Access Compliance Report

Public Rights-of-Way

(Curb Ramps)

Intersection ID: N/A	Main Street: INVERNESS_BAY_RD	Cross Street: ELGIN_MOOR_RD	Location: SE
ADA ID: 251577C0768B	Ramp Type: Perp	Initial Pass/Fail: Fail	Overall Compliance: No
Codes/Mitigation Info/Possible Solution		Field Measurements/Component Compliance	
Severity Score: 12.5

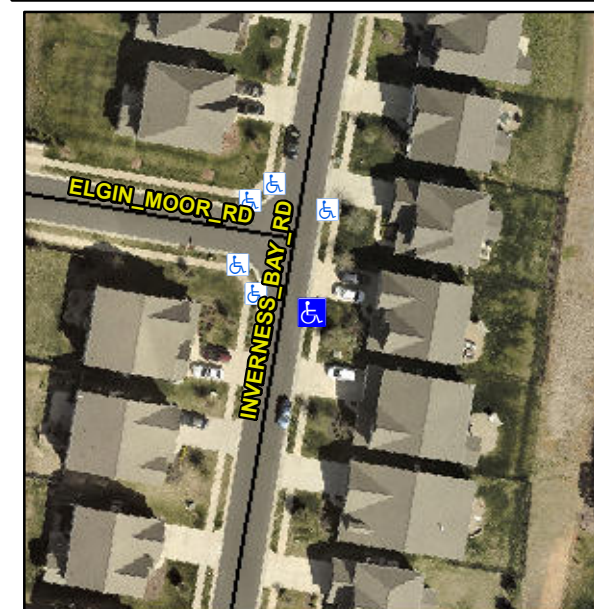
Not Found, R304.2.2

Compliance	Description	Data	Compliance	Description	Data
N/A	Ramp Length (in)	48.0	No	Ramp Slope (%)	8.5
Yes	Ramp Width (in)	48.0	Yes	Ramp XSlope (%)	0.0
N/A	Flare Type LT	N/A	N/A	Flare Type RT	N/A
N/A	Flare Slope LT (%)	N/A	N/A	Flare Slope RT (%)	N/A
N/A	Flare Traversable LT?	N/A	N/A	Flare Traversable RT?	N/A
N/A	Landing Length (in)	N/A	N/A	DWS Provided?	N/A
N/A	Landing Width (in)	N/A	N/A	DWS Contrast?	N/A
N/A	Landing Slope (%)	N/A	N/A	DWS Length (in)	N/A
N/A	Landing X Slope (%)	N/A	N/A	DWS Full Width?	N/A
N/A	Landing Curb? (Y/N)	N/A	N/A	DWS Offset (in)	N/A
N/A	Shared Landing?	N/A			
N/A	Gutter Ponding?	N/A	N/A	Gutter Slope (%)	N/A
N/A	Gutter Lip Ht (in)	1.0	N/A	Gutter X Slope (%)	N/A
N/A	Painted X Walk1?	No	N/A	Painted X Walk2?	N/A
	X Walk 1 Direction	To NW		X Walk 2 Direction	N/A
N/A	X Walk 1 Width (in)	N/A	N/A	X Walk 2 Width (in)	N/A
	X Walk 1 Slope (%)	3.9		X Walk 2 Slope (%)	N/A
	X Walk 1 X Slope (%)	1.6		X Walk 2 X Slope (%)	N/A

Remove & Replace Entire Ramp.
